United States Patent and Trademark Office

APPLICATION NO.	FILING DATE	FIRST NAMED INVENTOR	ATTORNEY DOCKET NO.	CONFIRMATION NO
10/699,496	10/31/2003	James L. Worrell	K112942P0041US	3171
32116	7590 05/12/2004		EXAMINER	
WOOD, PH	IILLIPS, KATZ, CLARI	K & MORTIMER	JIMENEZ, MARC QUEMUEL	
500 W. MAI	DISON STREET			
SUITE 3800			ART UNIT	PAPER NUMBER
CHICAGO,	IL 60661		3726

DETAILED ACTION

See illustration of Smith below:

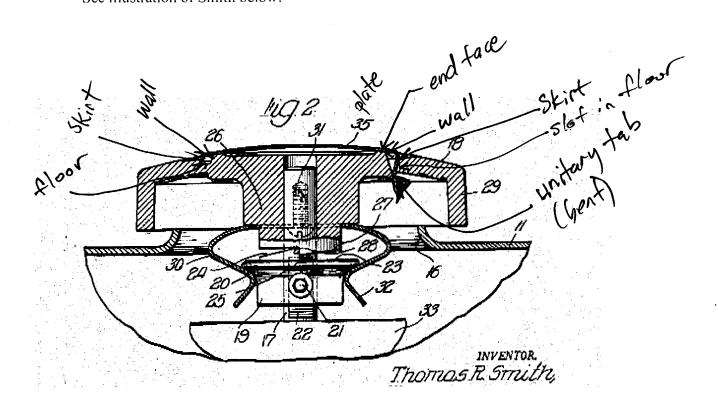
Smith teaches a method of making a knob by steps of: providing a body 18, which has a boss having an end face (see the face contacting 35) and having a wall and which has a recess (see below the numeral 26 in fig. 2) bordering the boss and having a floor (the horizontal plane below numeral 26 where 35 fits into of the body 18), the wall adjoining the floor, providing a cup 35, which is adapted to fit over the boss, which has a plate (col. 3, lines 13-14) adapted to cover the end face of the boss when the cup 35 fits over the central boss, and which has a skirt (see above numeral 27) adapted to encompass the wall of the central boss when the cup 35 fits over the central boss, the skirt (see above numeral 27) being unitary with the circular plate 35, and fitting the cup 35 over the boss so that the plate 35 covers the top of the central

boss, and so that the skirt (see above numeral 27) encompasses the wall of the boss, and securing the cup 35 to the body 18.

Regarding claim 2, Smith teaches that the skirt has a unitary tab projecting from the skirt and is caused to project through an associated slot in the floor (see above numeral 27)

Regarding claim 5, Smith teaches that the unitary tab (above numeral 27) has a distal portion which is bent to secure the cup 35 to the body 18.
